Business Event Center  
84x64x33H

Site: <b>13625 Noah Abel Pt</b>	Drawing: <b>111123</b>	Project: <b>AL2326</b>	Drawn:	Notes: Requesting special use permit on 40 acres.
Title: <b>Business Event Center</b>	Zone: <b>A-35</b>	Date: <b>11/11/2023</b>	Rev: <b>A</b>

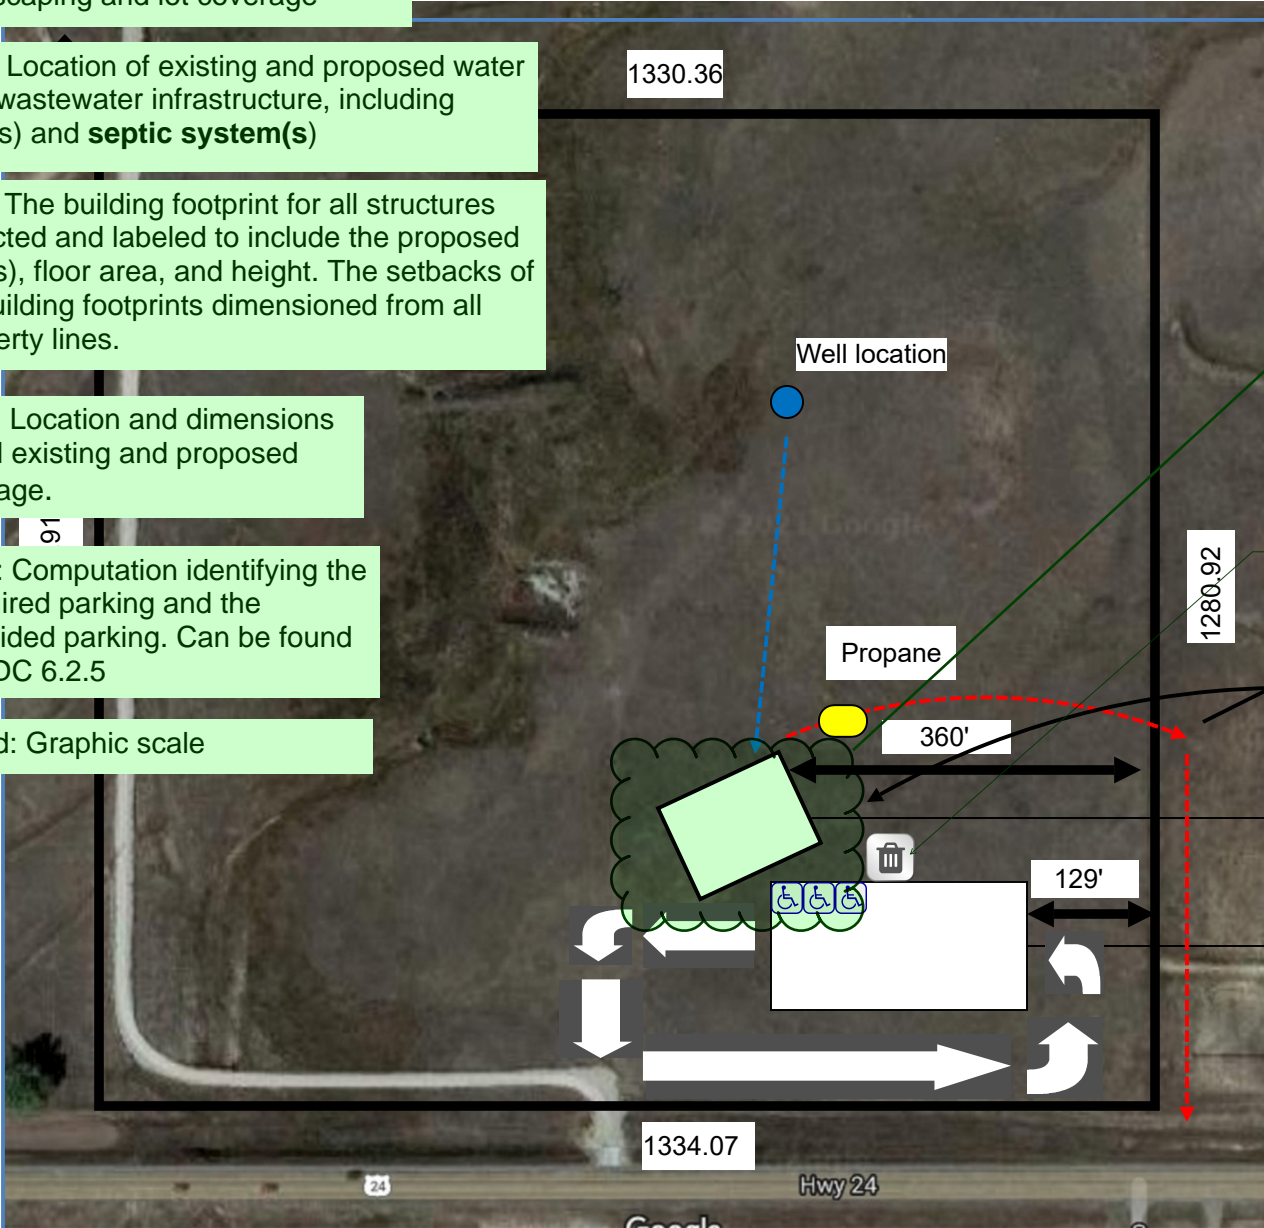
Add: Percent of open space, landscaping and lot coverage

Add: Location of existing and proposed water and wastewater infrastructure, including well(s) and **septic system(s)**

Add: The building footprint for all structures depicted and labeled to include the proposed use(s), floor area, and height. The setbacks of all building footprints dimensioned from all property lines.

Add: Location and dimensions of all existing and proposed signage.

Add: Computation identifying the required parking and the provided parking. Can be found in LDC 6.2.5

Add: Graphic scale

You stated in the LOI that 20% of the time guests will be outside of the structure. Is there a proposed patio reception area? If so, please add.

Is this a dumpster?

Applicant name,  
contact telephone  
number, and email for  
responsible party

Add property tax schedule number and legal description.
